Re: 1407 Warm Shell 1407 4th St. SW

Traffic Circulation Layout

Engineer's Stamp 12-15-22 (L14-D063A)

A1 EXISTING TRAFFIC CIRCULATION LAYOUT

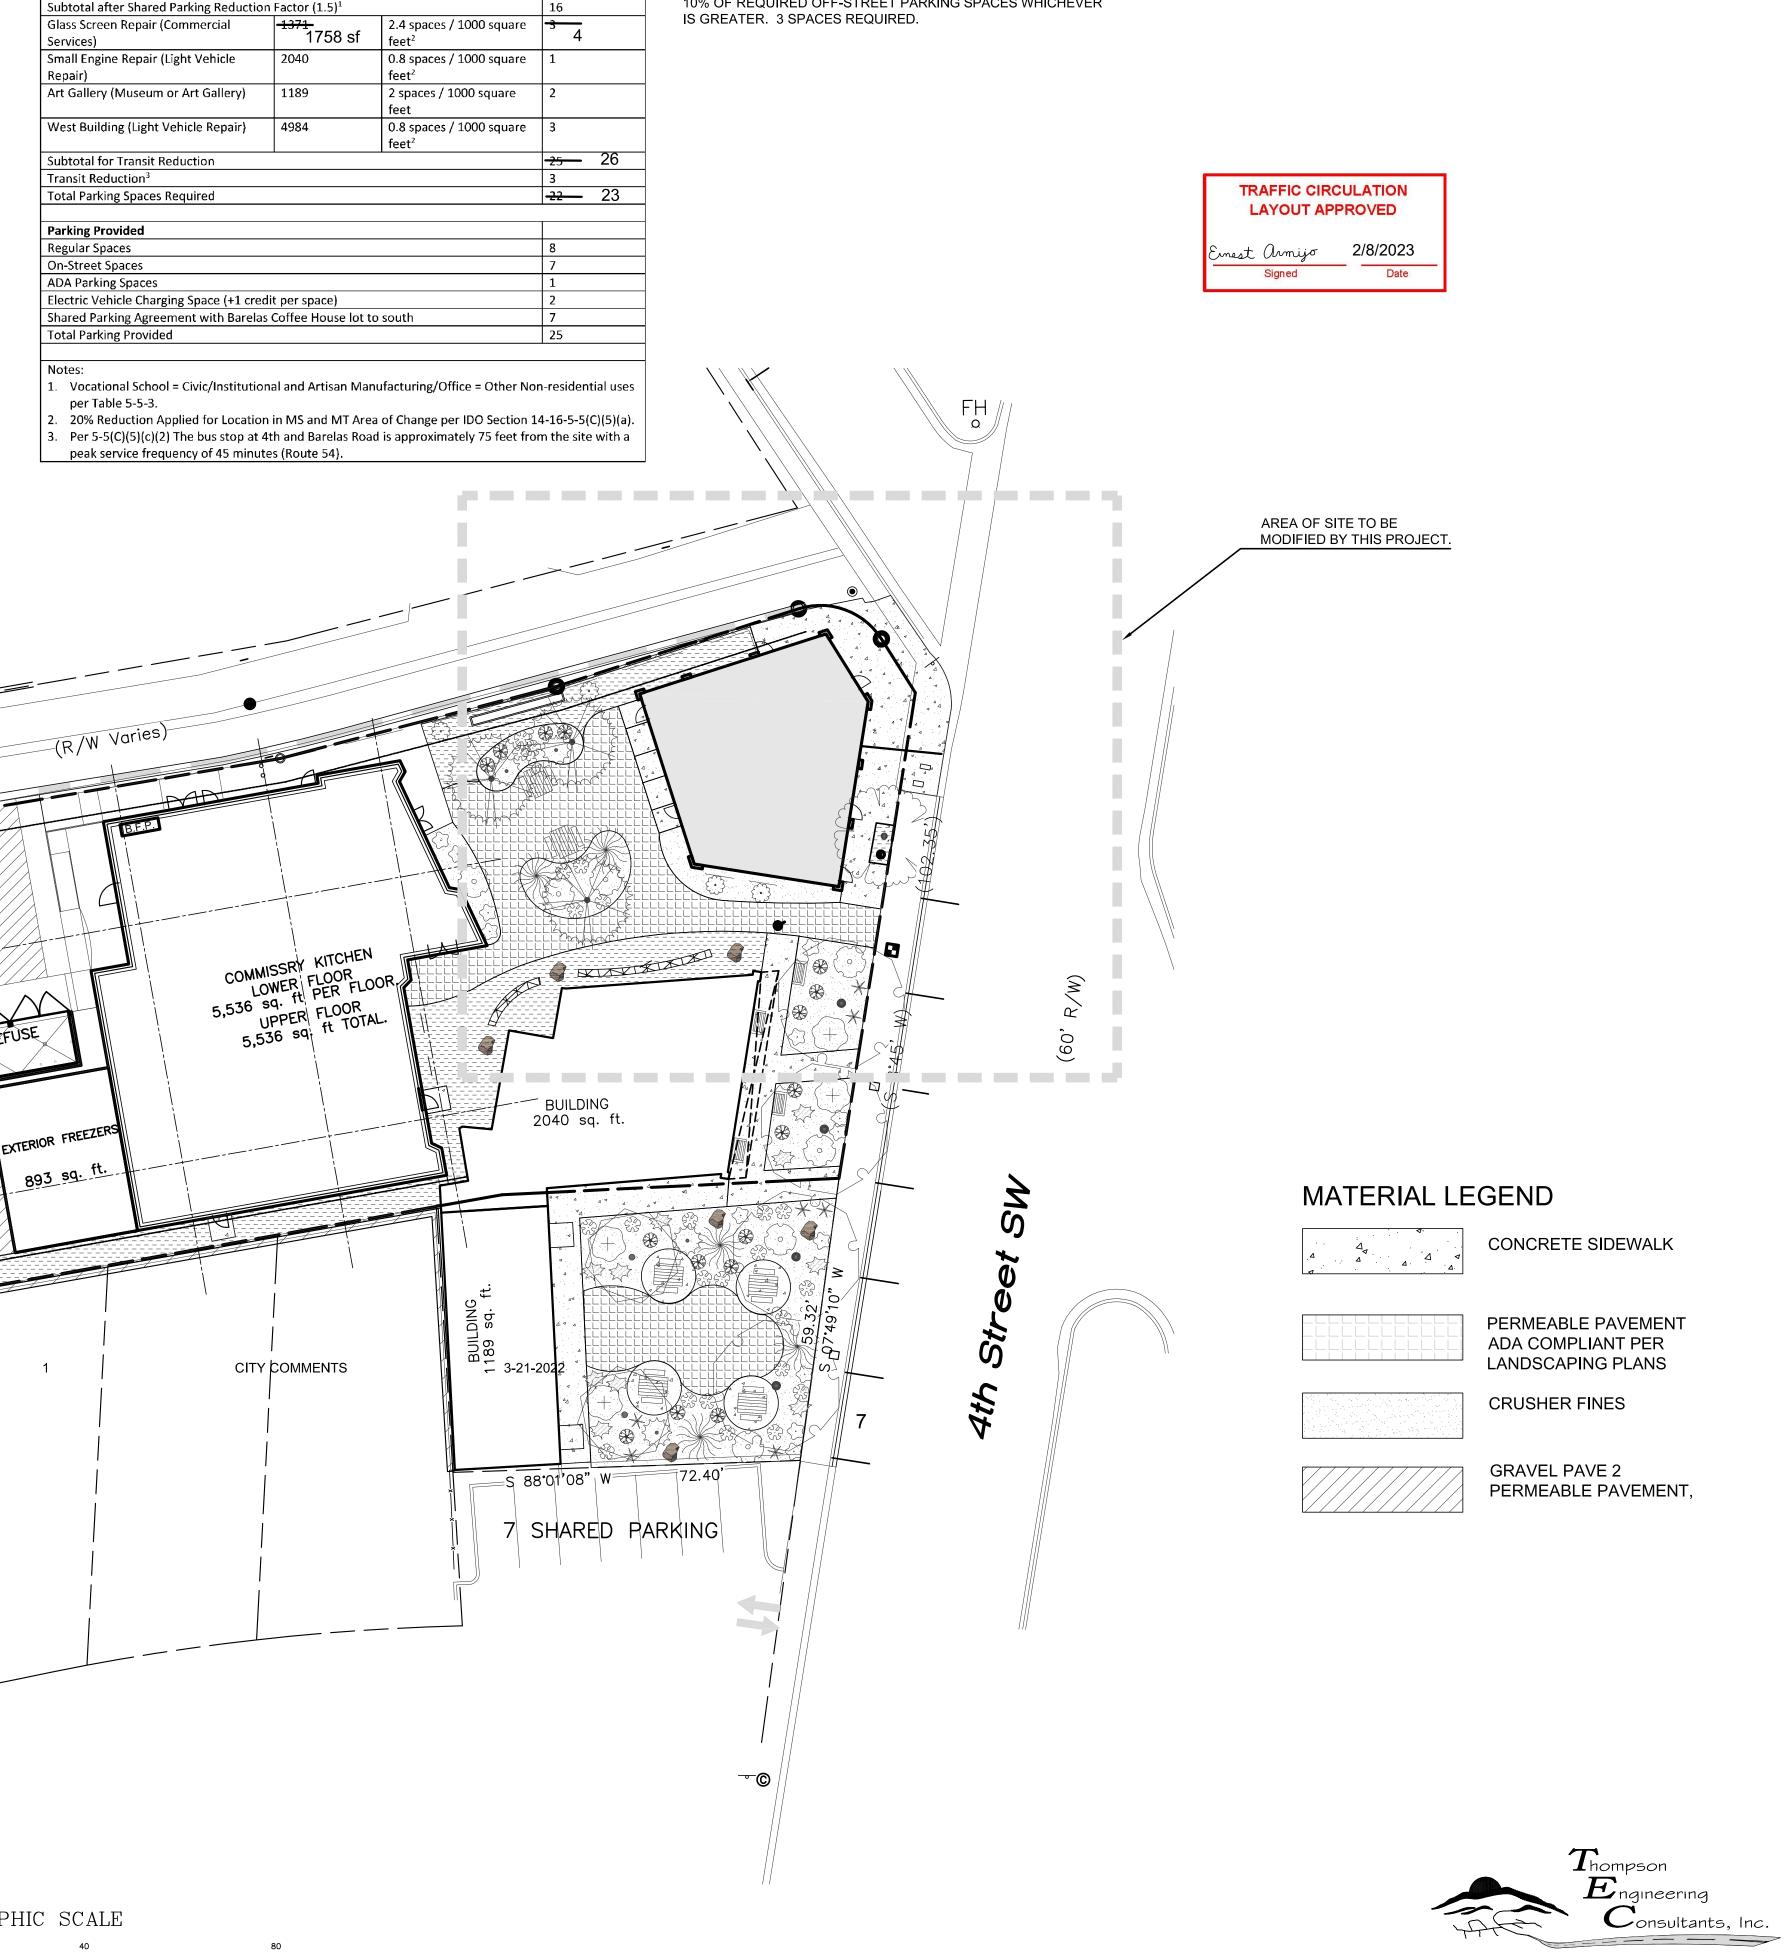
The TCL submittal received 01-09-2023 is approved for Building Permit by Transportation. A copy of the stamped and signed plan will be needed for each of the building permit plans. Please keep the original to be used for certification of the site for final C.O. for Transportation.
